Technical Service Bulletin Number TSB130113	Revision Level	Date	Group Number
--	----------------	------	--------------

ISX12 CM2350 X102 and ISX15 CM2350 X101 Fault Code 4585 After Calibration

19u00066

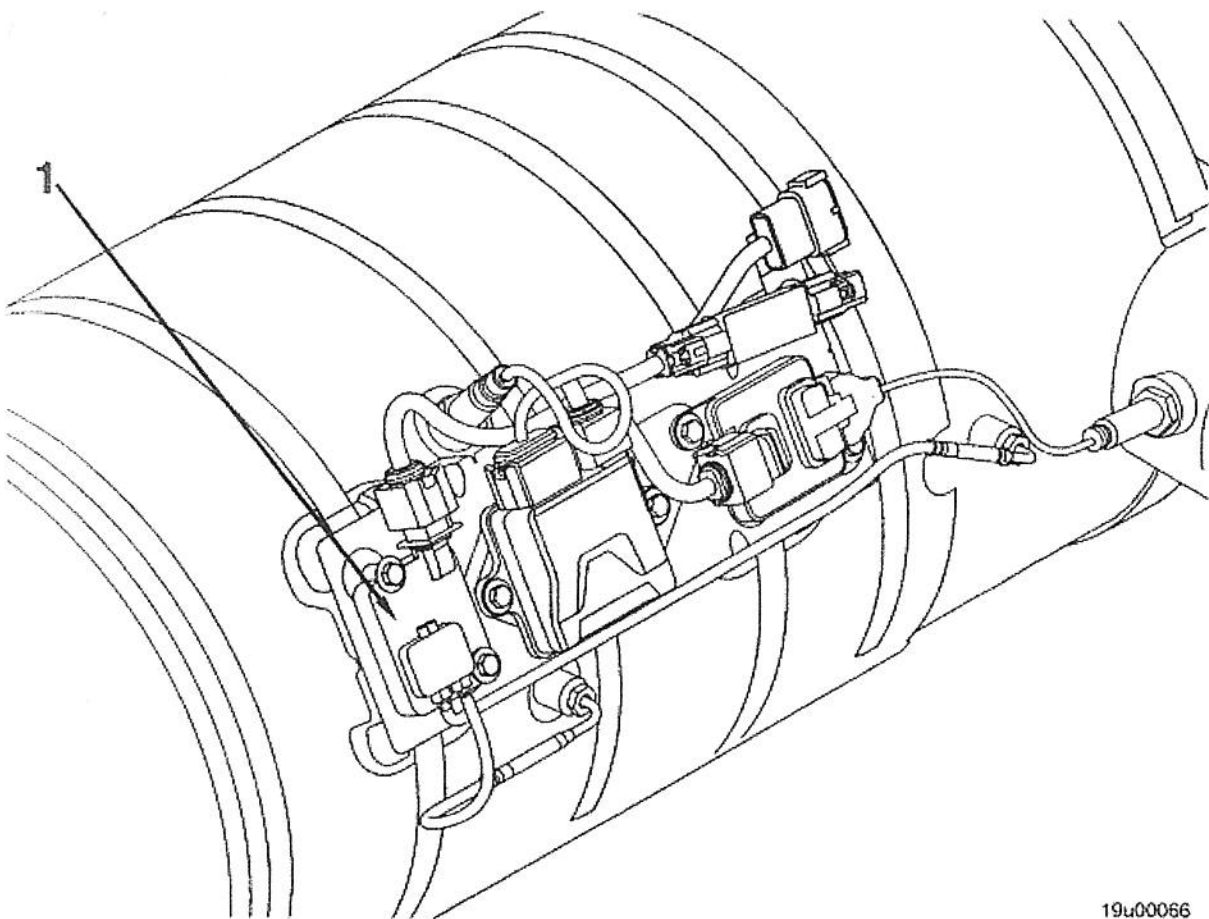
A population of ISX12 CM2350 X102 and ISX15 CM2350 engines do **not** have a compatible aftertreatment selective catalyst reduction (SCR) temperature sensor module. Fault Code 4585 is a diagnostic that runs continuously for the first 50 hours of Engine Run Time to verify calibration and SCR compatibility. When units calibrate the engine control module (ECM) to a calibration released after 21 June 2013, it requires a compatible SCR catalyst. If the unit does **not** have the compatible aftertreatment SCR temperature sensor module with the new calibration, Fault Code 4585 could become active.

When the unit has Fault Code 4585 active, it **must** be verified that a compatible SCR is installed.

To clear the active Fault Code 4585, a new aftertreatment SCR temperature sensor module, Part Number 4307100, **must** be installed.

NOTE: This is the same part number that is currently on the module. The aftertreatment SCR temperature sensor module (1) is shown below:
